CITY OF GARDEN CITY

File Number: DSRFY2021- 0011
Application Scope: Pre-application Conference with a Request for a Public Hearing
Location: 208 E 33rd St.
Applicant: Jason Jones, Wee Boise
Report Date: April 5, 2021
Revision Date: TBD

Staff Report
 Prepared by Hanna Veal

Figure 1: Staff illustration of how live and work units relate to one another within the development.

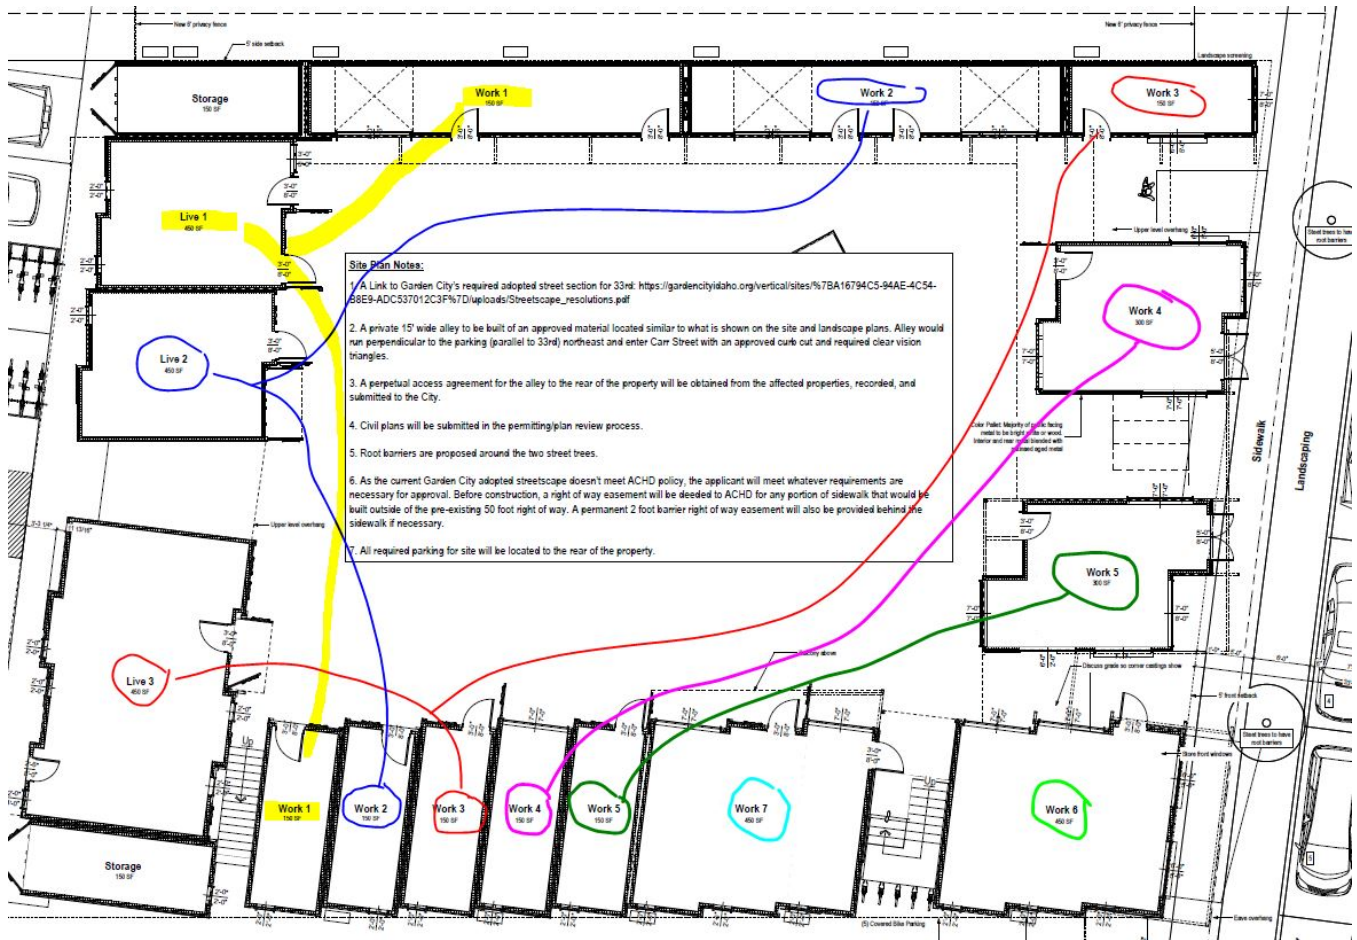
8-3C-3B General Provisions-Workspace Requirements		Compliant as conditioned	<p>Subsection B. requires a minimum of 250 sq. ft. for interior working spaces.</p> <p>There is a total of 2,700 workspace proposed with each work space ranging between 300 and 450 square feet.</p> <p>Some workspaces are split into two different units. For example, Workspace 1 is split up into two 150sqft spaces for a total of 300sqft of working area. One workspace is on the</p>

<p>north of the complex while the other is on the south side. (Exhibit 1) The total workspace square footage for units such as this range between 300sqft and 450sqft, with Work Unit 5 being 450sqft total. All meeting the minimum 250sqft requirement.</p> <p>Potential drafted conditions of approval include:</p> <ol style="list-style-type: none"> 1. All live spaces must have an associated indoor workspace of at least 250 square feet on the site. 2. A legal mechanism shall be produced, to be reviewed administratively, that links the use of the live units to its intended workspace. 3. All workspaces have must an associated live space on site that has been reviewed and approved through the building permit process as a dwelling.
8-3C-3C General Provisions – Living Space Requirements		No compliance issues noted	<p>The proposed live spaces are all 450 square feet. The minimum size is 220 square feet and cannot exceed an average size of 1,000 square feet. Based on staff's understanding, the applicant would like some flexibility in the spaces so that they can best meet tenants needs.</p> <p>There was no submittal of floor plans, not enough information to review. The requirements of a bedroom, closet space, bathroom and kitchen can be evaluated administratively during the building permit process as These requirements do not directly affect the exterior of the structures.</p> <p>Subsection C.5 requires a minimum of 80 sq. ft. of outdoor open space provided for each living space and is satisfied through porches, patios, decks, and/or yards. Required setbacks, landscaping, entryway and other accessways cannot count toward this minimum. There is the requirement of 560sqft of open space.</p> <ul style="list-style-type: none"> • According to Cover Sheet G1, there is 5800sqft. of outdoor plaza. • According to Site Plans, there are multiple balconies, outdoor patios, and a pollinator garden, but the exact square feet is not disclosed. • There is an outdoor upper patio pop up space of 300sqft. • Landscape plans indicate there is a courtyard, but it is not shown in the site plans.
